# Service Bulletin

Bulletin No.: 18-NA-260

**Subject:** Air Conditioning (A/C) Not Cooling, A/C System Low or Empty of Refrigerant

Brand:	Model:	Model Year:		VIN:		Engine:	Transmission:
		from	to	from	to		
Chevrolet	Cruze	2016	2019	—	—	—	—

4376998

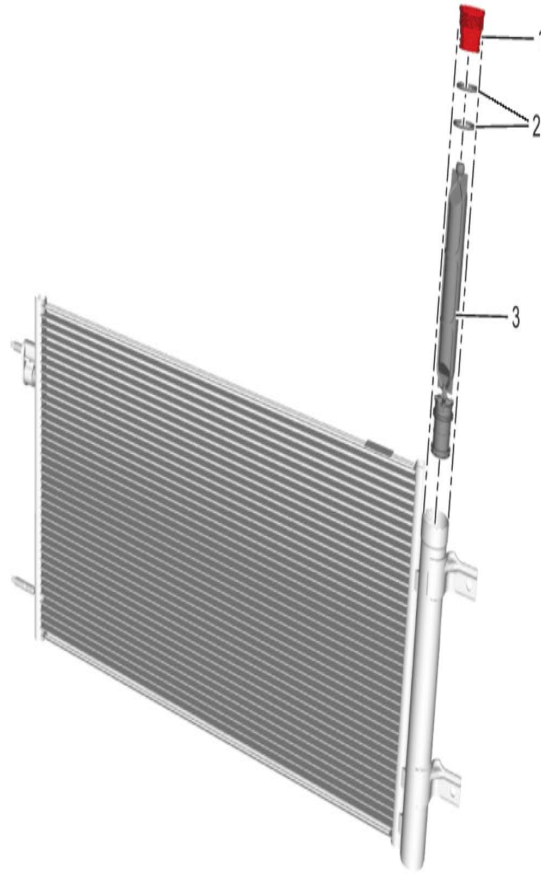
Perform an A/C system leak test to verify that the leak is coming from the A/C receiver and dehydrator plug (1). Refer to *Leak Testing (Fluorescent Dye Method)* in SI.

If there is a leak coming from the A/C receiver and dehydrator plug, replace the A/C receiver and dehydrator using the service kit called out in this bulletin.

**Important:** When replacing the A/C receiver and dehydrator plug, apply a light coating of poly-alkylene glycol (PAG) oil to the O-rings prior to installing the plug into the condenser.

5135784

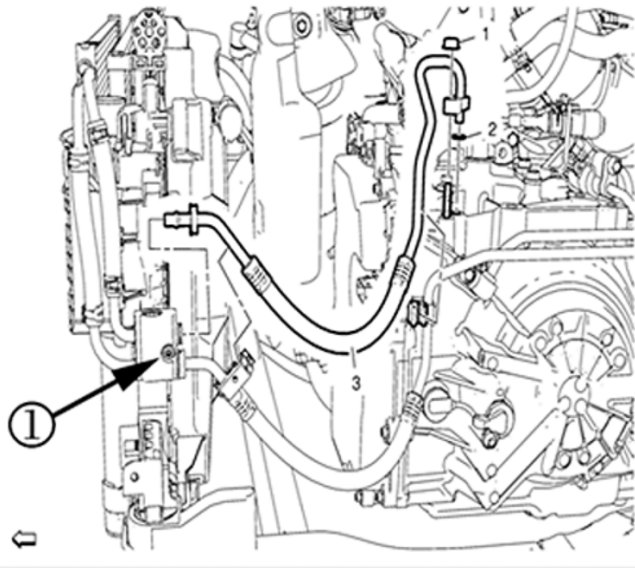
1. Reposition the transmission cooler by removing the hose bracket bolt (1), lifting the cooler from the mounting points then carefully lowering the cooler out of the way to access the A/C receiver and dehydrator plug.
2. Replace the A/C receiver and dehydrator assembly with the appropriate service kit.
